Client
Kings Keeley Limited C/o Clearbell Capital LLP
Project
65 Kingsway - Base Scheme

Title
Demolition Section BB

Drawing No.
1914-BG-01-ZZ-DR-A-15.252

01
15.202
Demolition Section BB
1:100@A1, 1:200@A3

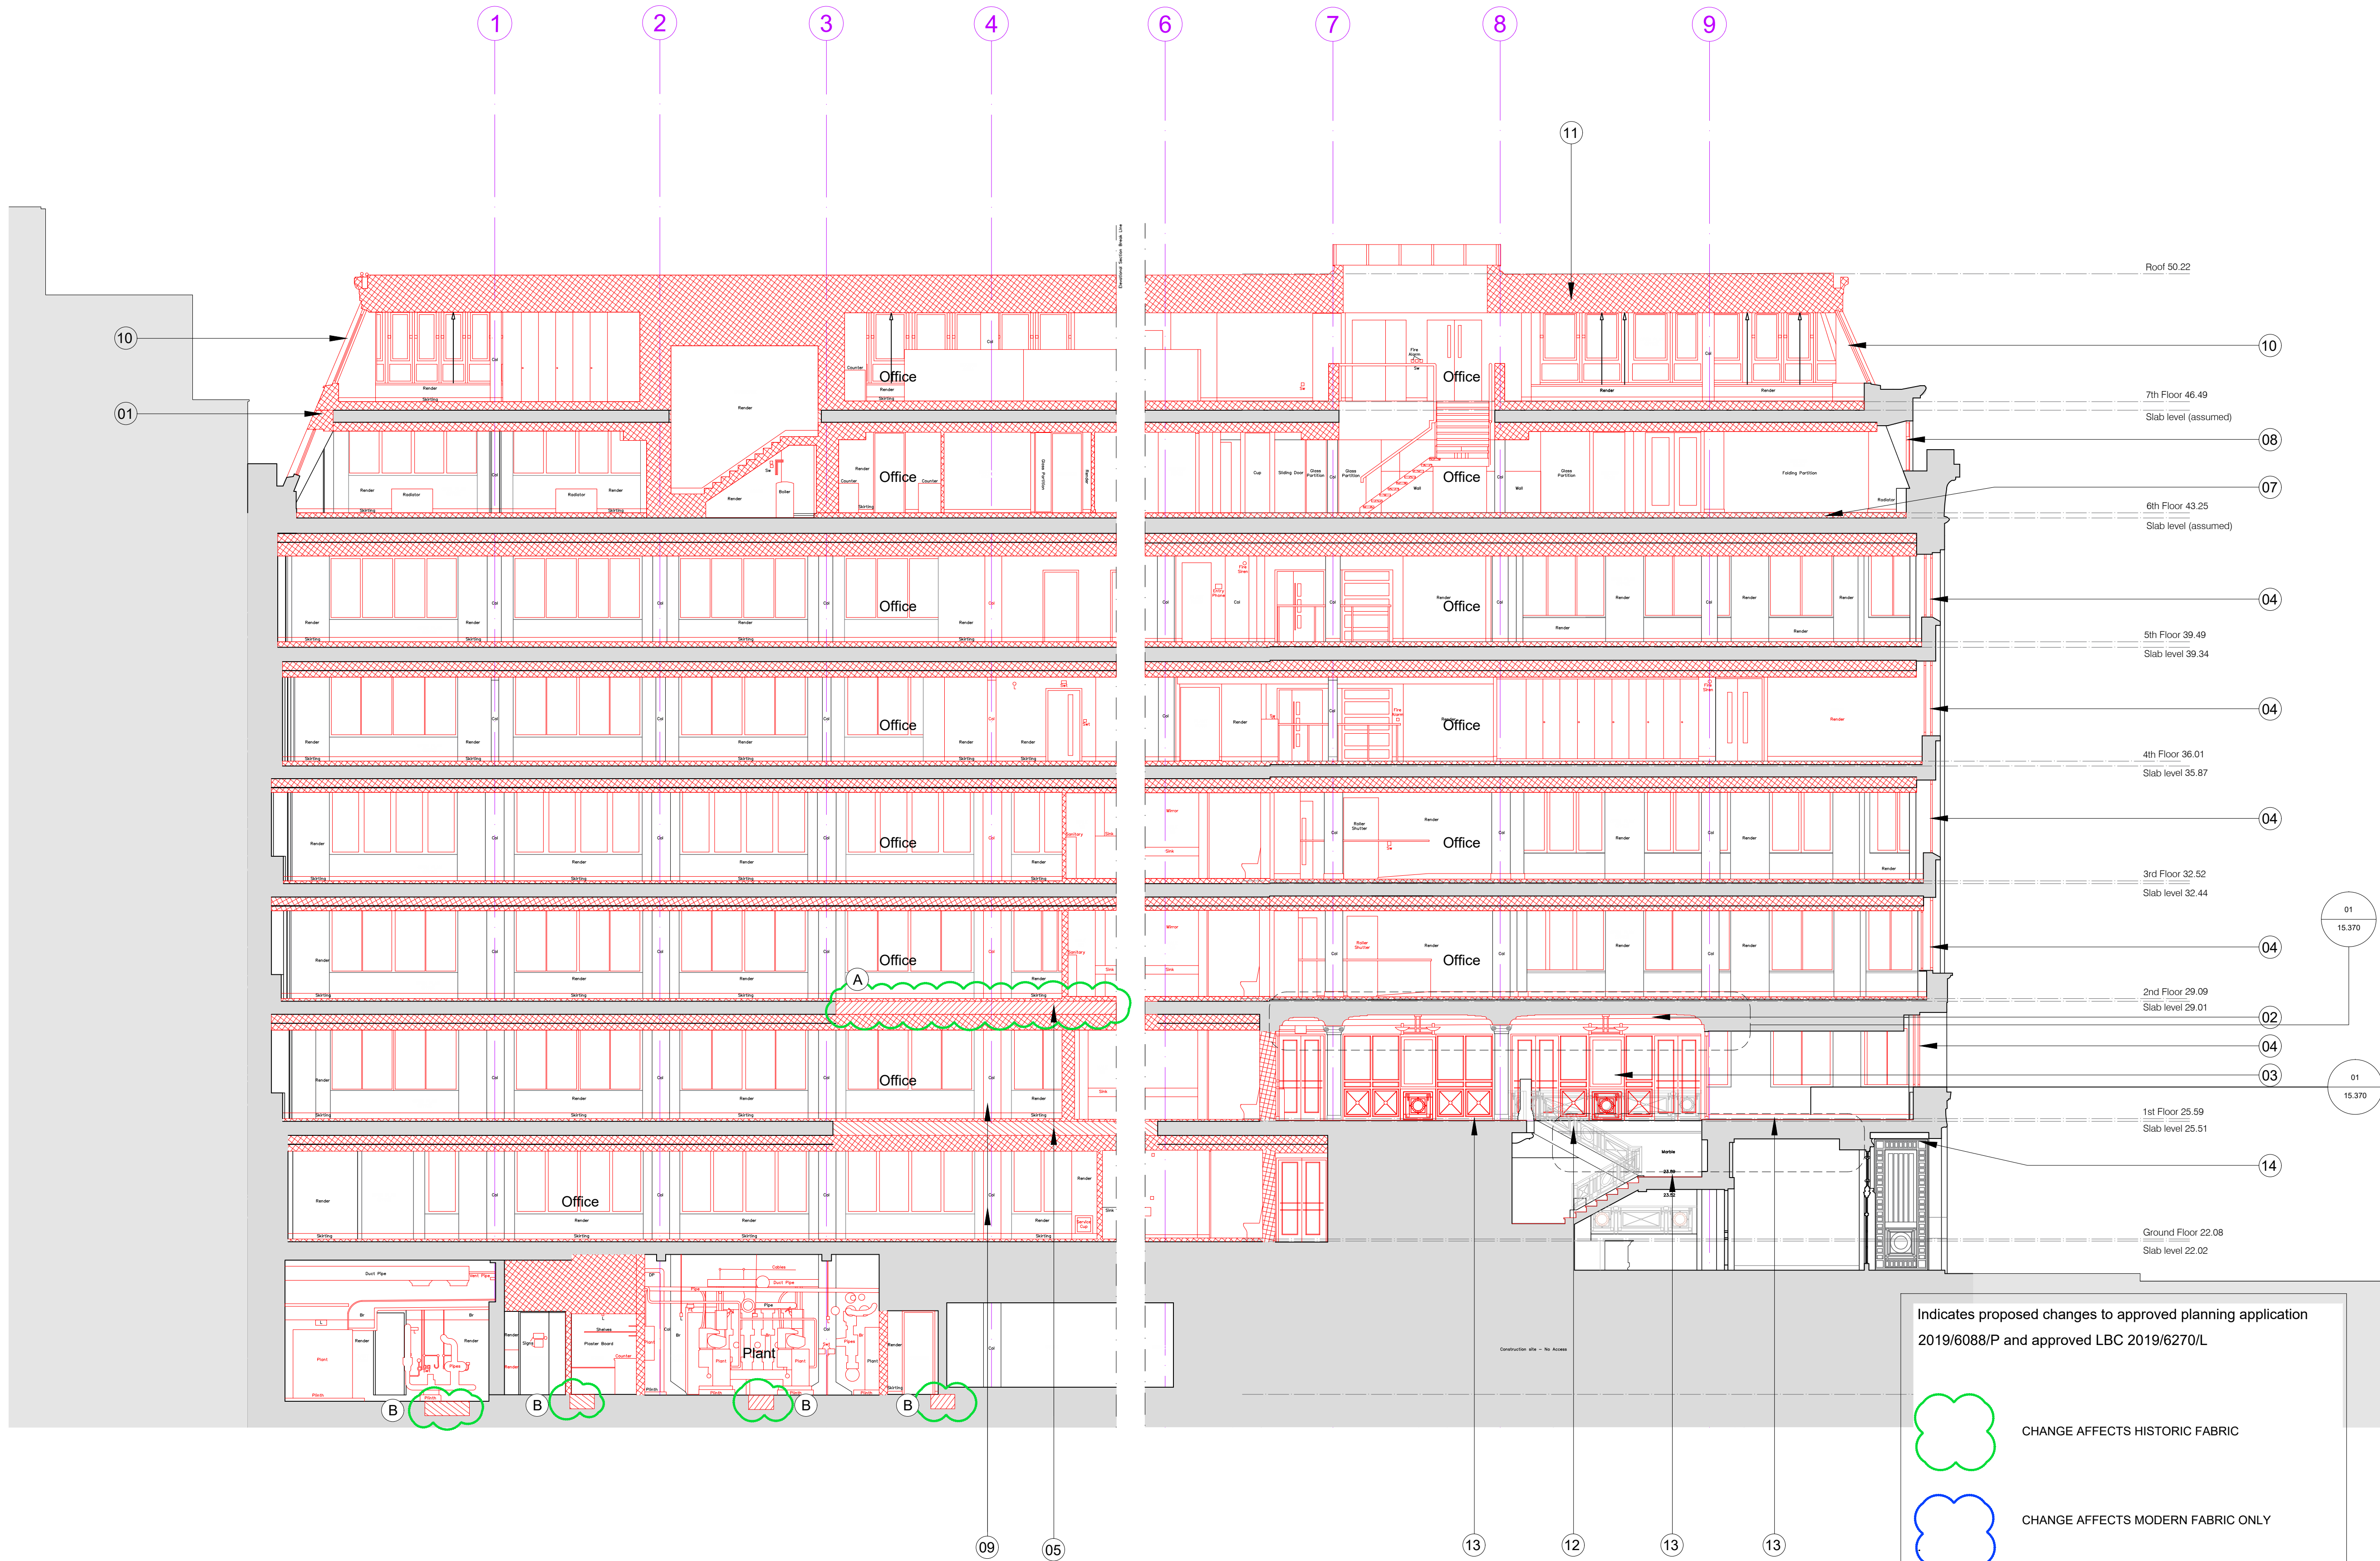
- A. Slab demolition between Grid lines B-D/ 3-5, in order to facilitate the removal of the columns on 1F. See 15.203 First Floor Demolition plan. Refer also to HTS drawings and SK91.
- B. Extent of slab demolition at Basement level for drainage route amended.
